4/2016/MIN/A - 272-280 NORMANBY ROAD, SOUTH MELBOURNE

**LOCATION/ADDRESS:** 272-280 NORMANBY ROAD, SOUTH MELBOURNE  
**EXECUTIVE MEMBER:** LILI ROSIC, GENERAL MANAGER, CITY STRATEGY AND SUSTAINABLE DEVELOPMENT  
**PREPARED BY:** PATRICIA STEWART, FISHERMANS BEND URBAN RENEWAL SENIOR PLANNER

**1. PURPOSE**

1.1 To provide a Council position for an application to the Minister for Planning to prepare, adopt and approve an Amendment to the Planning Scheme under Section 20(4) of the Planning and Environment Act for 272-280 Normanby Road, South Melbourne, including for the Fishermans Bend Standing Advisory Committee.

**Figure 11.3.3:** Extract from Urban Design Memo prepared for the proponent by Hansen Urban Design Team and dated 03/06/2020

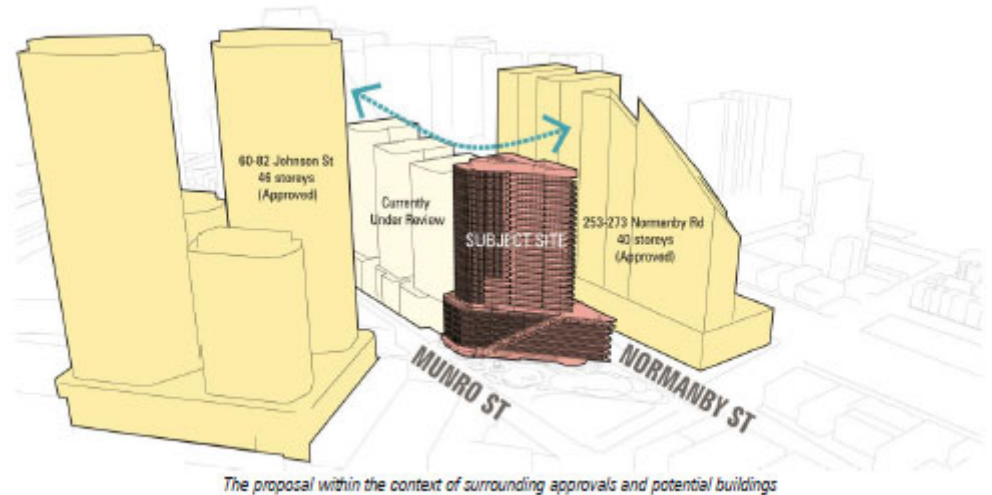
Council's Urban Designers recommend the proposed development at 10 storeys above the preferred building height outlined in DDO30 be reduced to a height more in keeping with the proposed precinct character. It could also reduce its impact by quoting the expressed roof form of the adjacent development. This could be achieved by incorporating a sloped roof form of its own that compliments the adjacent building's site response and contributes to develop the characteristic and reduce its visual impact

It is however noted this site would sit in context with the site immediately to the south of the road reserve at 253-273 Normanby Road at 40 storeys. That site (253 Normanby Road) has a sloping roof form that reduces its overshadowing and visual bulk and an expressed roof form that also delivers a unique characteristic to the precinct, as identified by Council's Urban Designers

The reduction in tower height from the 40 levels of the original 2016 planning permit application to the current proposed 30 levels is considered a satisfactory response to the preferred and emerging precinct character where development in excess of the 20 and 24-storey preferred heights have been approved prior to the current planning scheme controls but are only now commencing construction. An illustration below from an Urban Design Memo prepared for the proponent by Hansen Urban Design Team dated 03/06/2020 shows the emerging massing surrounding the subject site. It is noted there is an additional proposal in the background at 2-28 Montague Street which is currently with the Standing Advisory Committee to consider three towers of 26, 28 and 34 storeys.
